HISTORIC AND DESIGN REVIEW COMMISSION

December 20, 2017

HDRC CASE NO: 2017-502
ADDRESS: 1021 N PALMETTO
LEGAL DESCRIPTION: NCB 1369 BLK 6 LOT N 46 FT OF 8 & 9 ARB A-1
ZONING: R-4 H
CITY COUNCIL DIST.: 2
DISTRICT: Dignowity Hill Historic District
APPLICANT: Ricardo McCullough
OWNER: Benfield Real Estate LLC
TYPE OF WORK: Construction of 2-story single family home
APPLICATION RECEIVED: December 5, 2017
60-DAY REVIEW: February 3, 2018

The applicant is requesting final approval to construct a 2-story single family home on the vacant lot at 1021 N Palmetto.

ROOF TOP TERRACE PLAN

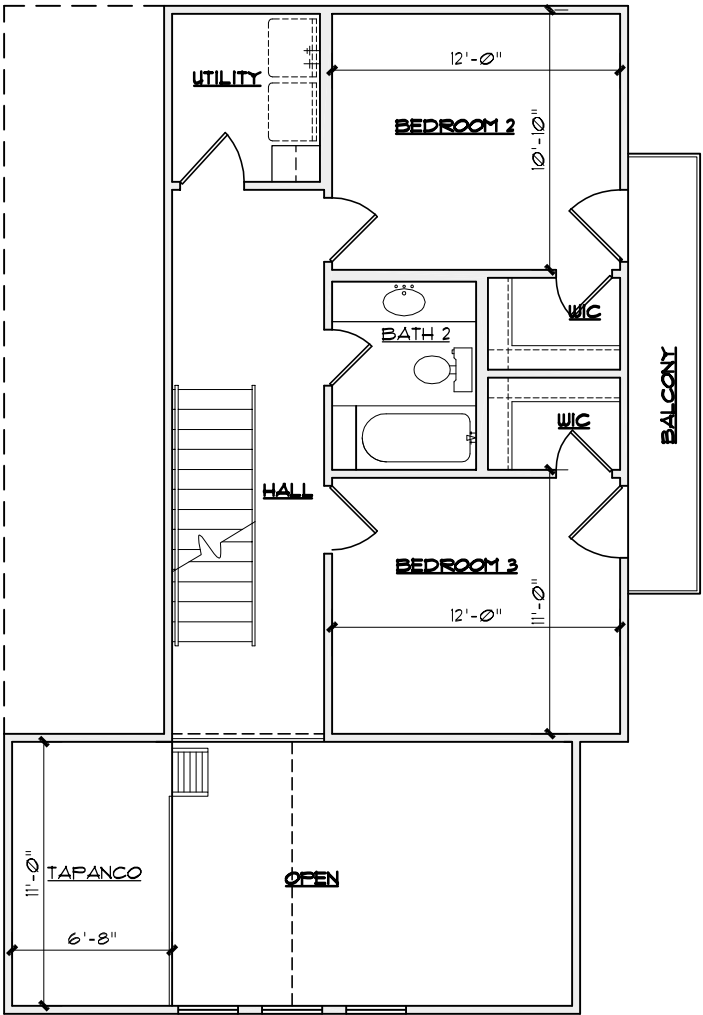
- i. **ROOF FORM** – The applicant has proposed a gable roof form and a habitable flat rooftop terrace on the rear elevation. The proposal also includes a chimney-like element with a small gable to provide access to the rooftop terrace. The cross gable pitch is commonly found in the Dignowity Hill Historic District. Guideline 3.A.iv states that new metal roofs should be constructed in a similar fashion as historic metal roofs in the district. Staff finds the gable roof form and terrace condition conceptually consistent, but finds that the chimney element holds no precedent and is not appropriate. Staff finds that the standing seam metal roof should feature panels that are 18 to 21 inches wide, seams are 1 to 2 inches in height, and a crimped ridge seam.

We lowered the pitch of the second floor roof from 8:12 to 6:12 to lower the ridge height. We created a chimney-like element for the door to access the roof top terrace. The siding will be 6" wood and cedar. The windows were changed from fix glass to single hung.

FRONT ELEVATION

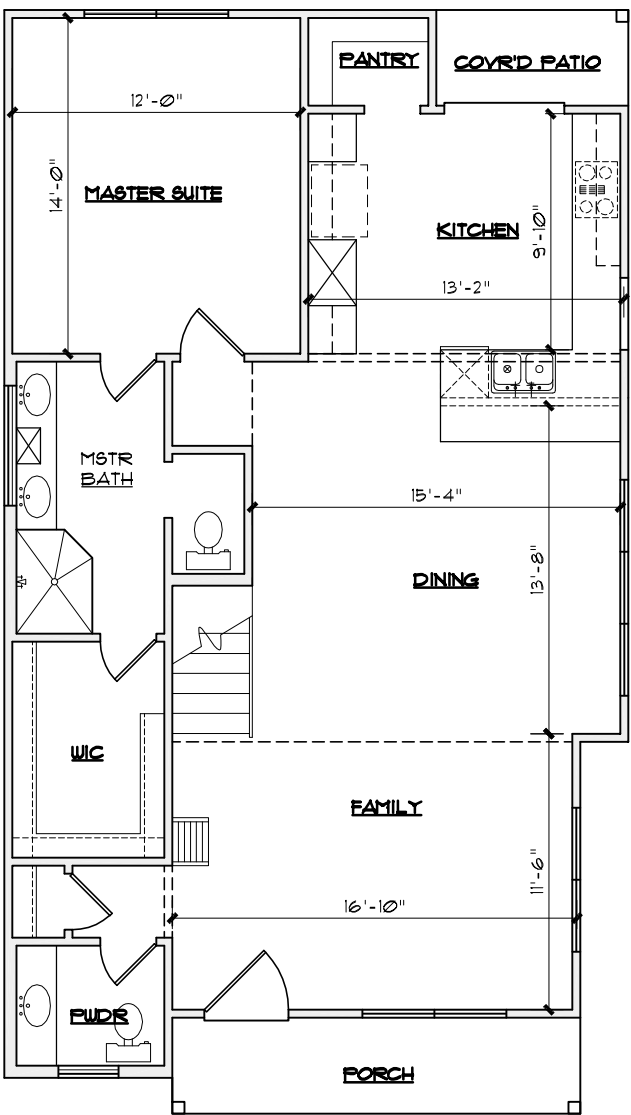
- f. **ENTRANCES: PORCH** – The applicant has proposed a front entrance that projects approximately one foot from the primary setback of the front façade. Historic structures throughout the Dignowity Hill Historic District feature distinct porches that engage the pedestrian streetscape and feature numerous widths, depths and roof styles. The proposed porch is limited in depth, which does not have a precedent in the district. The submitted drawings also contain several inconsistencies in terms of porch column placement and depth. Staff finds the proposal as submitted inconsistent with the Guidelines.

- i. That the applicant reduces the floor plate height to reduce the overall height of the structure as noted in finding g.
- ii. That the applicant removes the proposed chimney roof element and proposes an alternative solution for access to the rooftop terrace as noted in finding i.
- iii. That the applicant explores a front façade design that creates a true porch condition. The porch should extend towards the street and feature more depth to be more consistent with the porch depths and configurations of the

LEFT ELEVATION

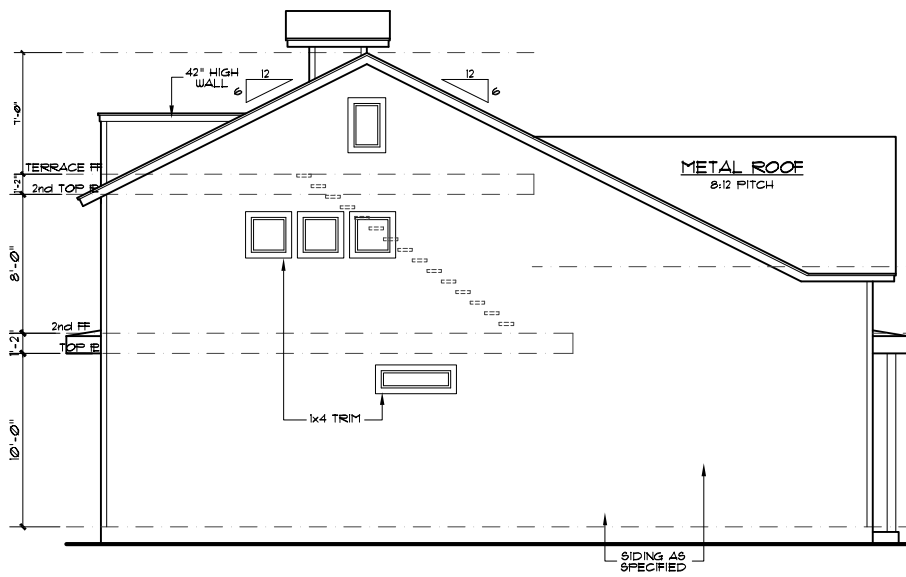
- j. **WINDOW & DOOR OPENINGS: PROPORTIONS AND PLACEMENT** – Per the Guidelines for New Construction 2.C.i., window and door openings with similar proportions of wall to window space as typical with nearby historic facades should be incorporated into new construction. The applicant has proposed several window openings that are consistent with historic precedents. However, staff finds that the left elevation features window sizes that are not consistent with the Guidelines, OHP Window Policy Document, or historic patterns in the district.

- iv. That the applicant proposes windows on the left elevation that feature proportions and configurations that are more consistent with historic window patterns in the district as noted in finding j. Staff finds one over one windows to be appropriate and encourages the applicant to carry the window pattern of the three other elevations over to the left elevation for consistency.
